**SUPPLEMENTAL INFORMATION
ADDENDUM NO. 3**

PROJECT: ITB No. 19-008 - Fort Howard & Old Augusta Road Roundabout

DATE ISSUED: July 3, 2019

SHEET NO. 9 / 47
DRAWING NO. 15-02

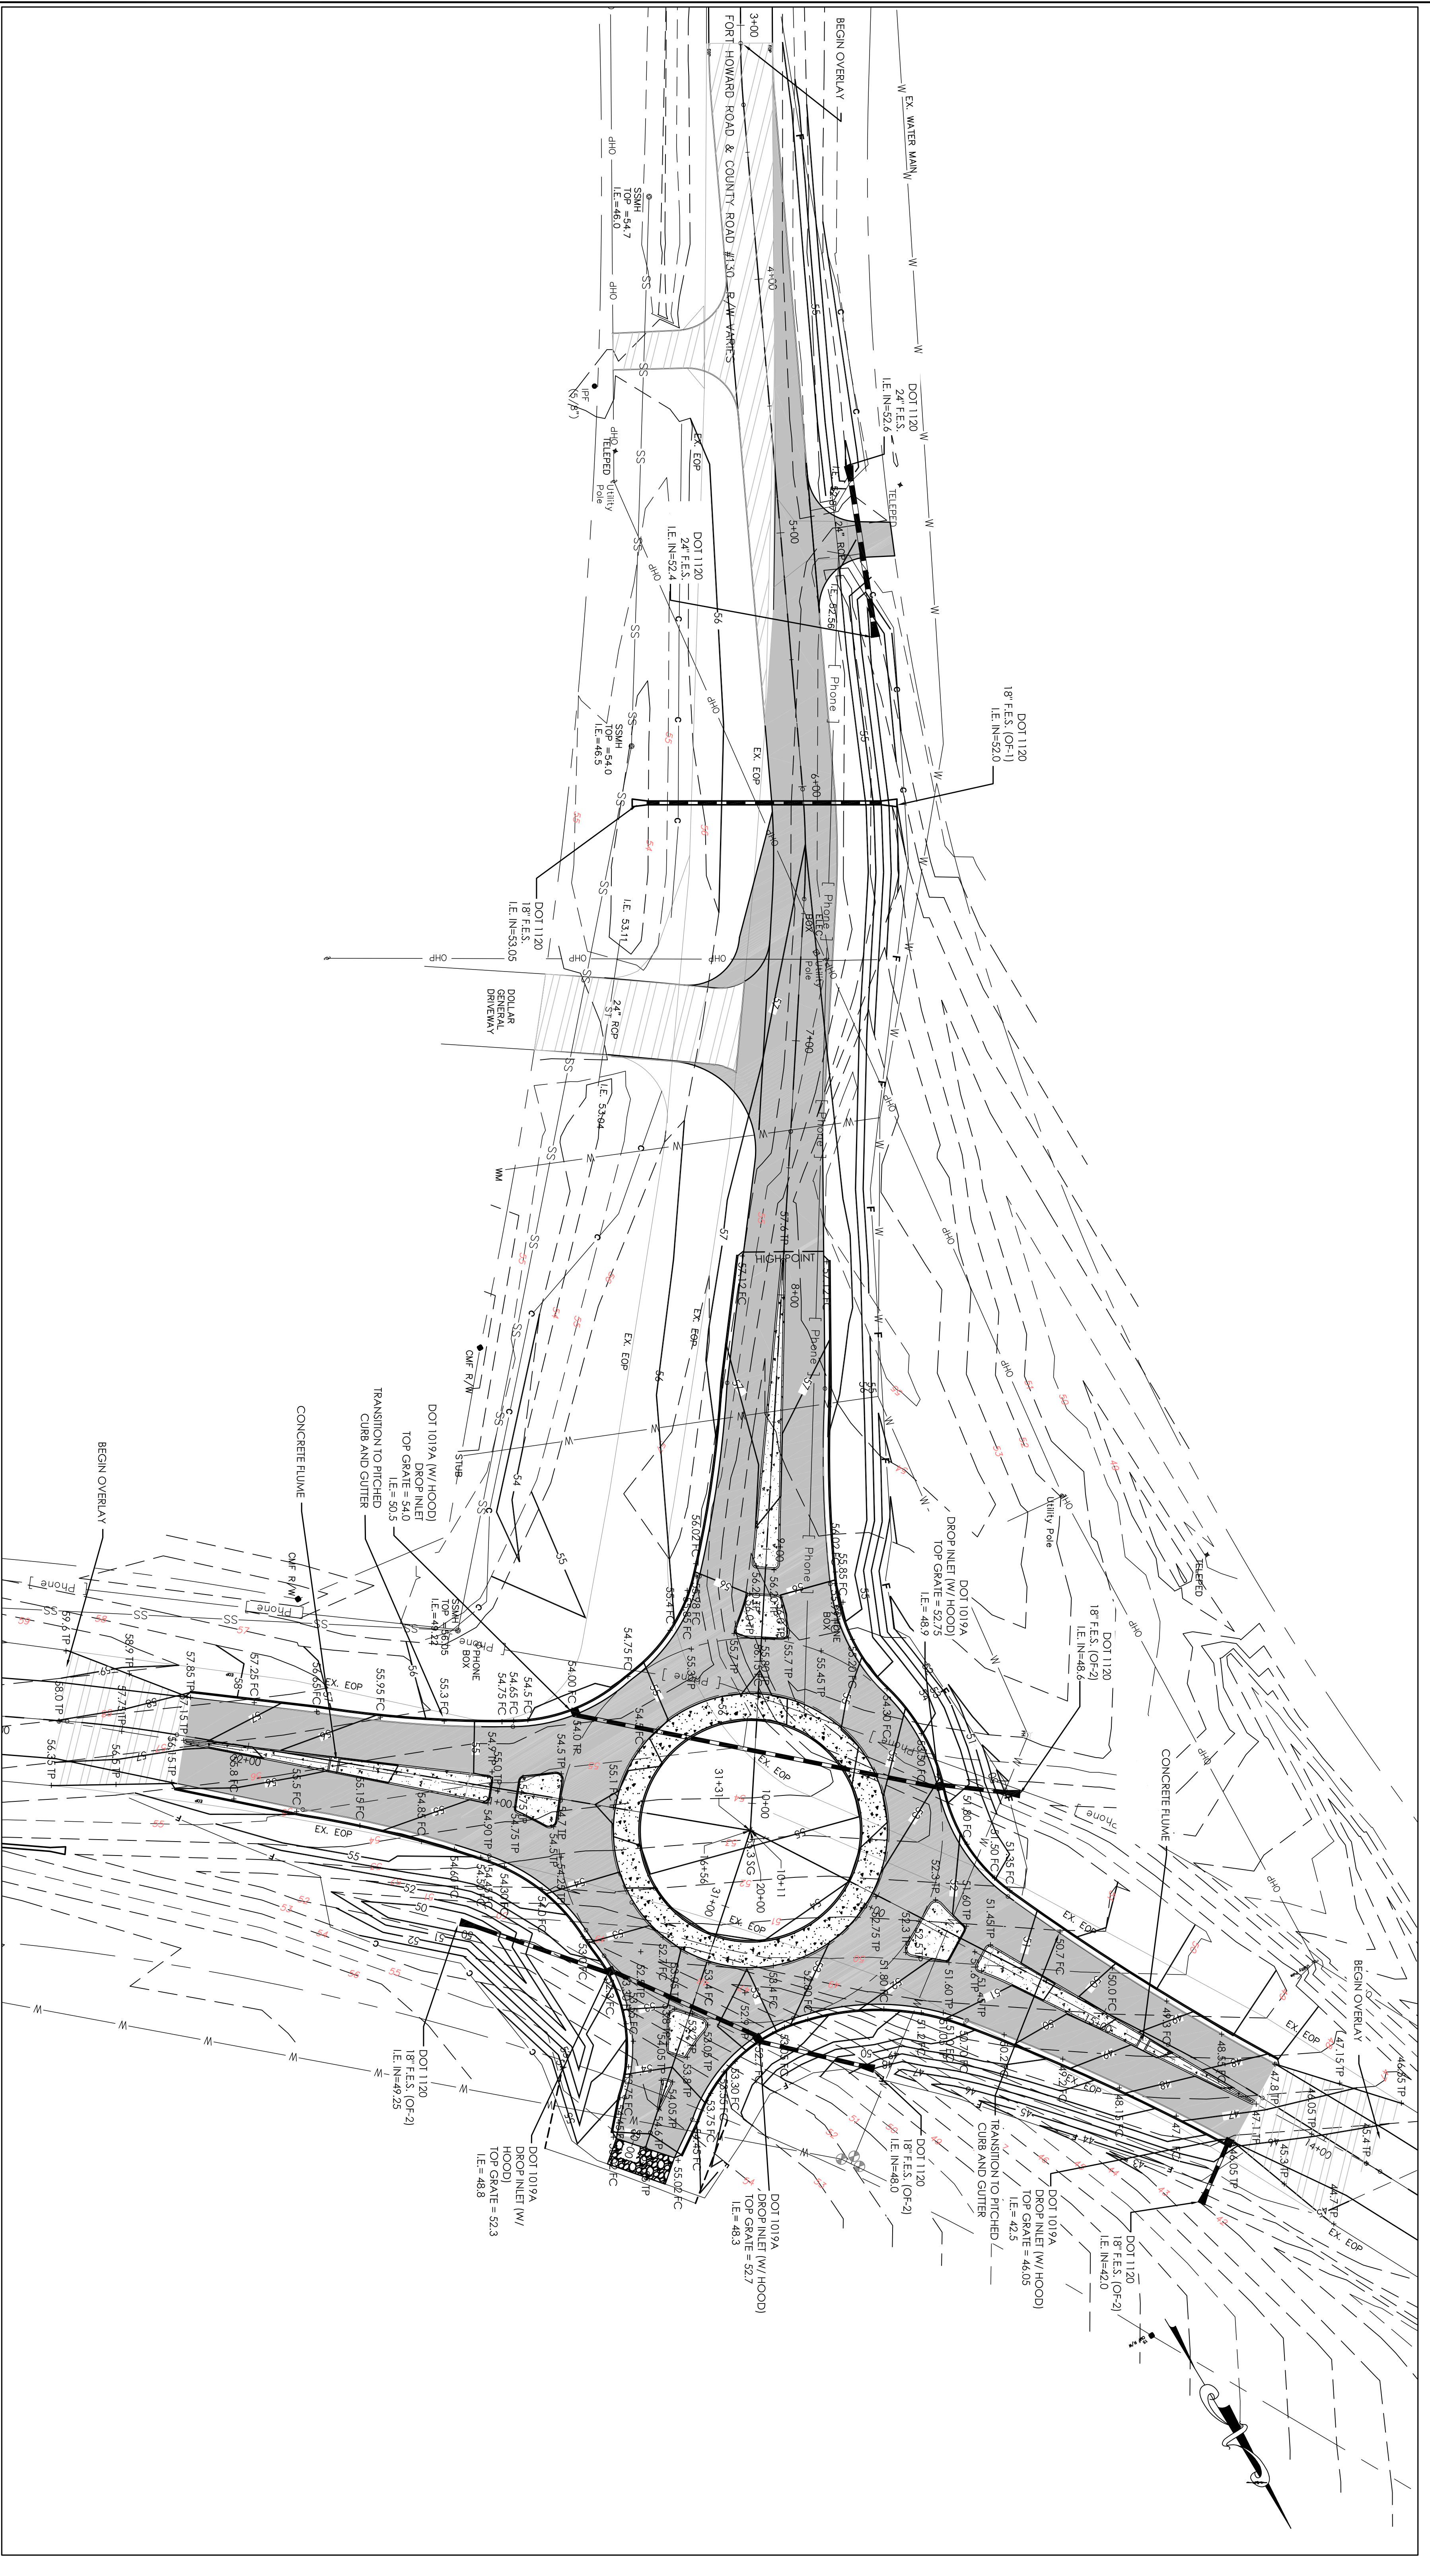
- 10) QUESTION: Please review the storm pipe schedule and revise quantities as needed. Sheet 6-01 lists 32’ of 18” RCP at station 23+00, but I cannot locate this pipe. Also seems that the 24” RCP has been left off the Bid Form.

ANSWER: The 32’ of 18” RCP is a driveway pipe that is shown as approximately located on sheet 15-02, though it was not labeled. The pipe will be labeled on this sheet. You are correct about the 24” RCP; it and the corresponding FES will be added to the bid form.

DRAWING NO. 5-01

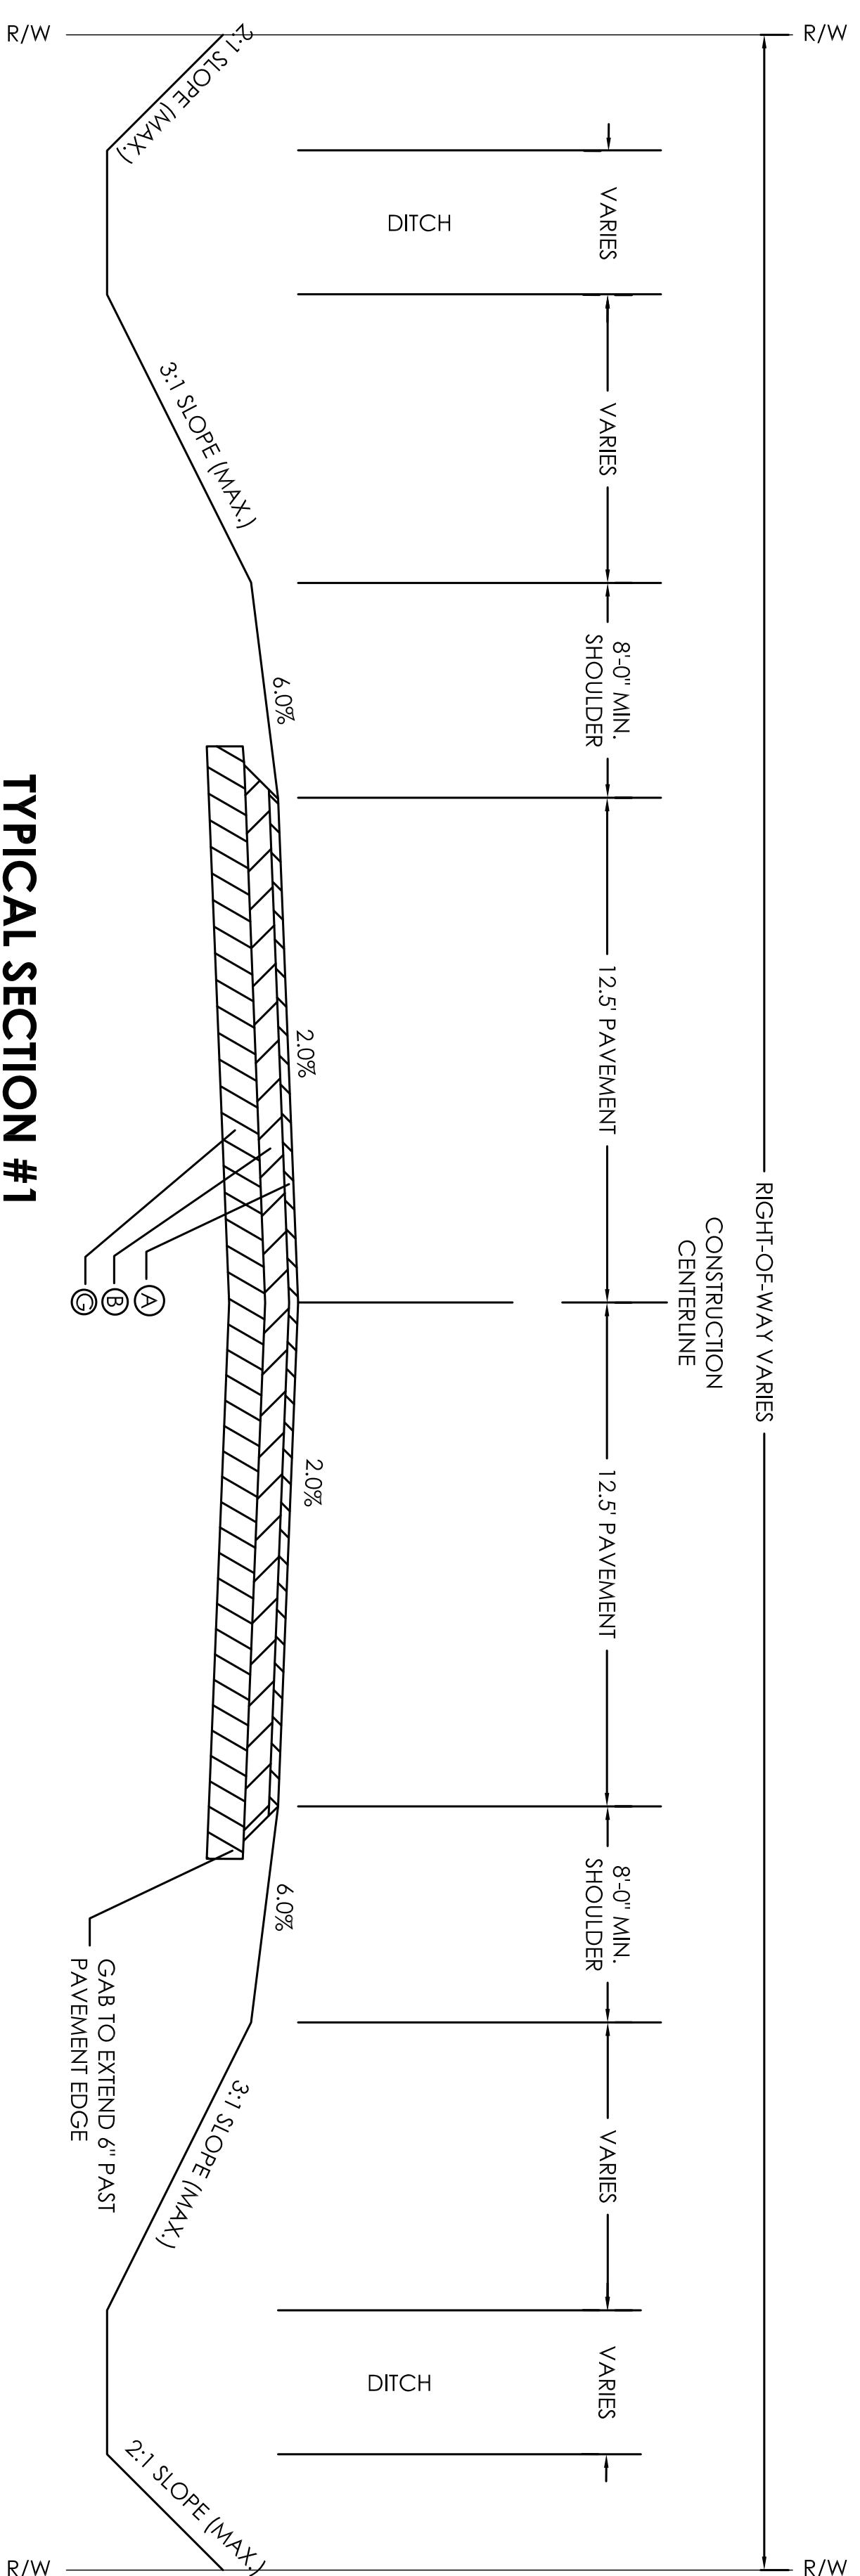
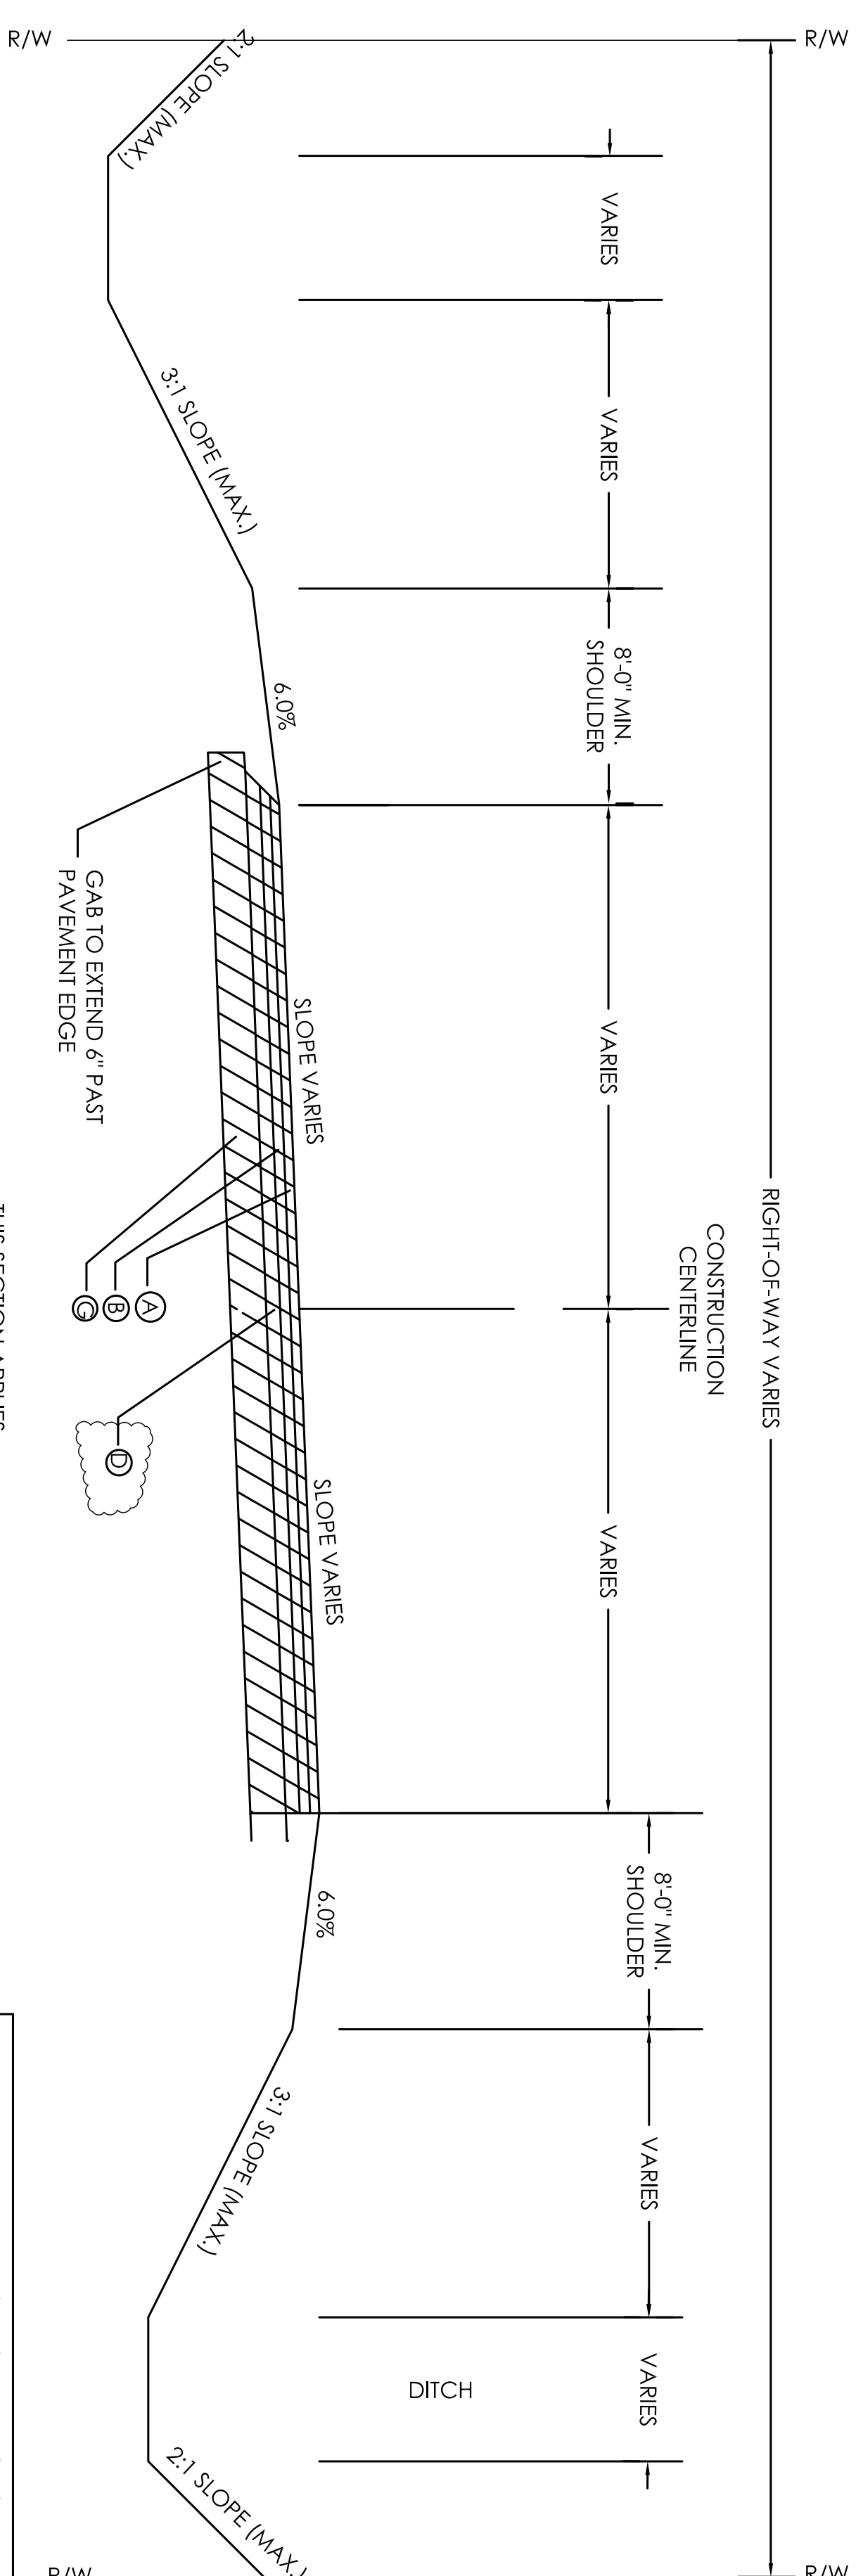
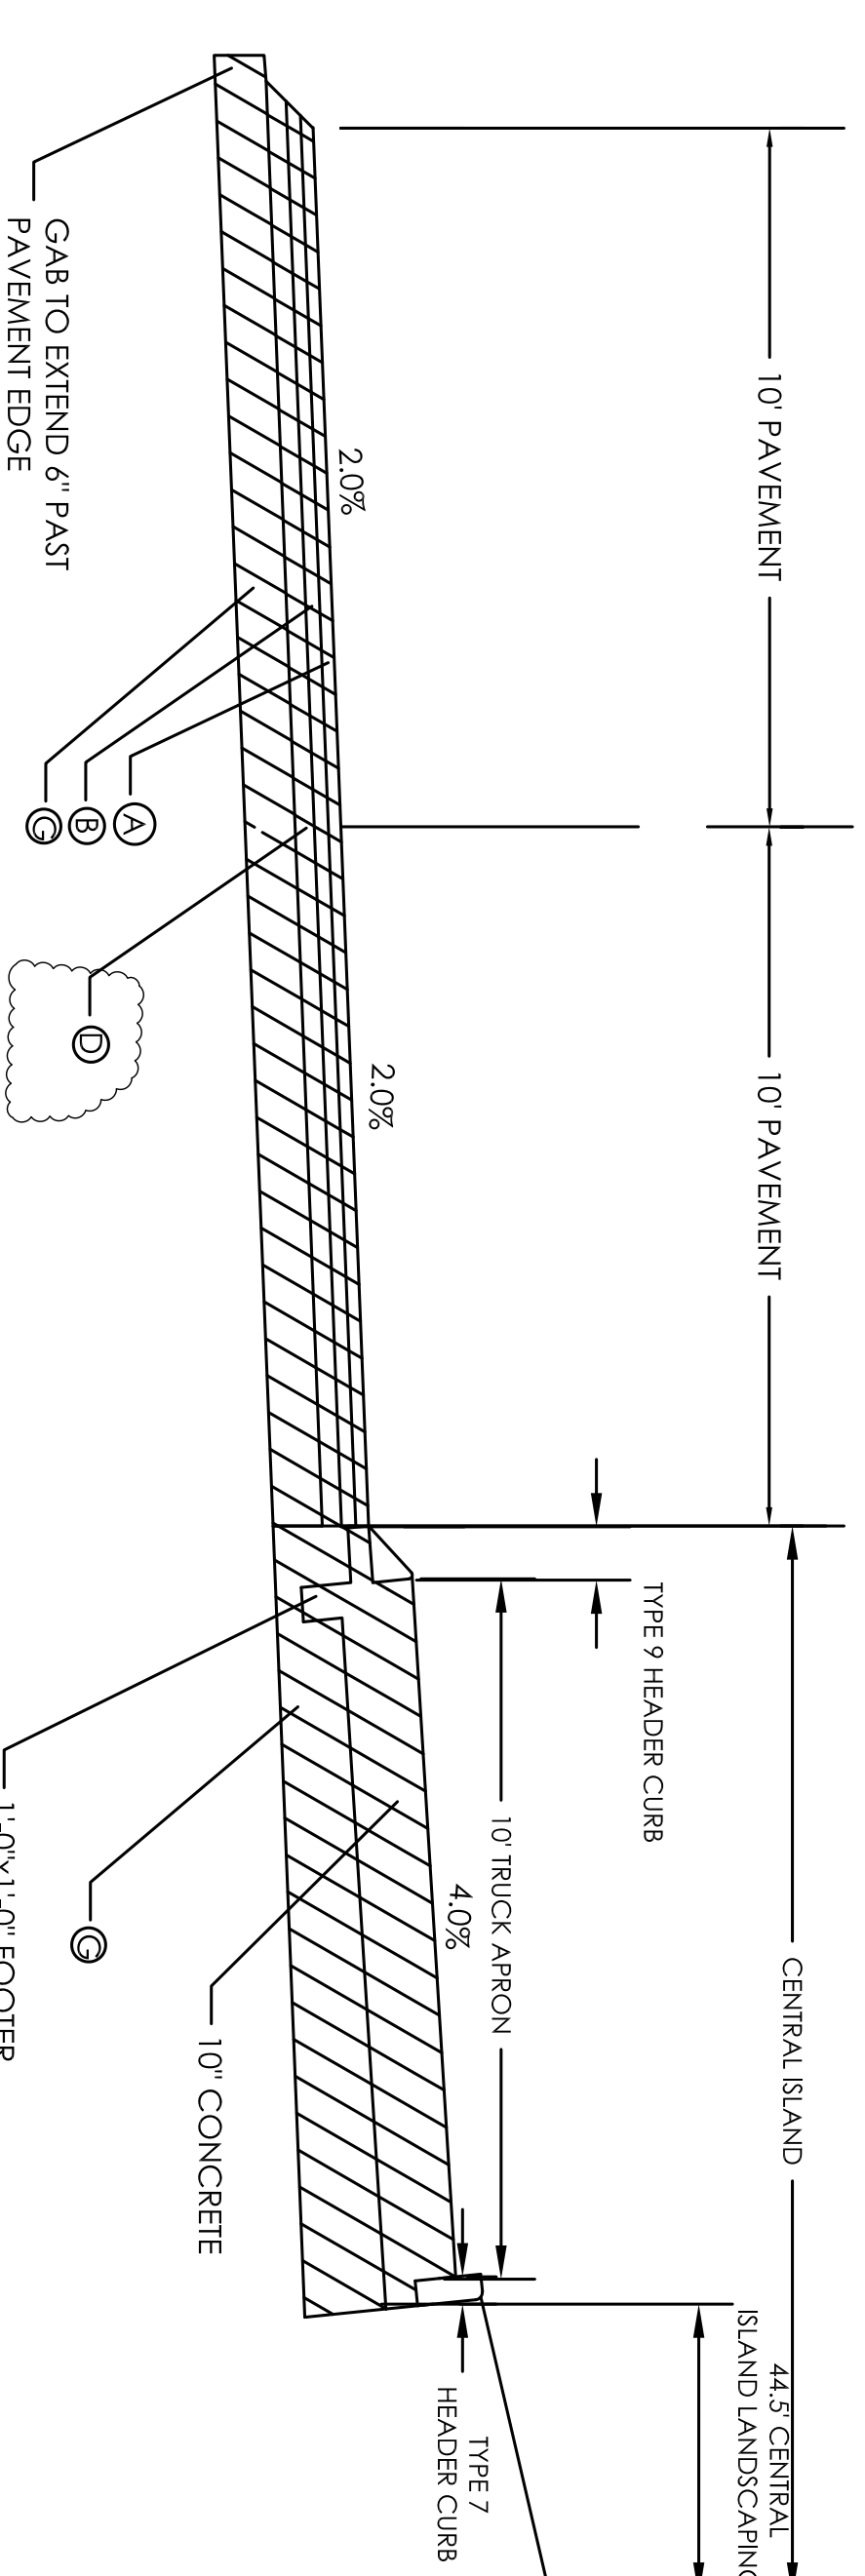
- 2) **QUESTION:** In the plans general note number 2 states that drives shall be constructed with 165 lb/sy of 12.5mm asphalt. The summary of quantities page shows 60 tons of 19.0mm to be placed on drives.
- a. Would the county please clarify if the drives will only require 12.5mm asphalt over GAB or both 12.5mm and 19.0mm asphalt over GAB?
 - b. If the 19.0mm is not required on the drives, would the county please adjust the 19.0mm asphalt to reflect this deduct?

- 3) **QUESTION:** In the plans all three typical sections for this project do not reference placing any 25.0mm asphalt (D, E). The summary of quantities page shows 630 tons of 25.0mm to be placed on the project. Would the county please clarify if the typical sections are correct in stating that no 25.0mm is required, however if this mix is required would the county please revise the typicals to reflect as such?

- a. See note on sheet 5-01. Only 12.5 MM superpave (1.5") is required for drives only to be overlain. Full depth pavement drives shall mirror cross section thickness for typical section #1.
- b. See item 2a.

ANSWER: For typical sections 2 and 3, the bottom asphalt layer letter should be "D" (25 MM asphalt), not "C" (more 19 MM asphalt). Typical section can be found at the end of the Addendum.
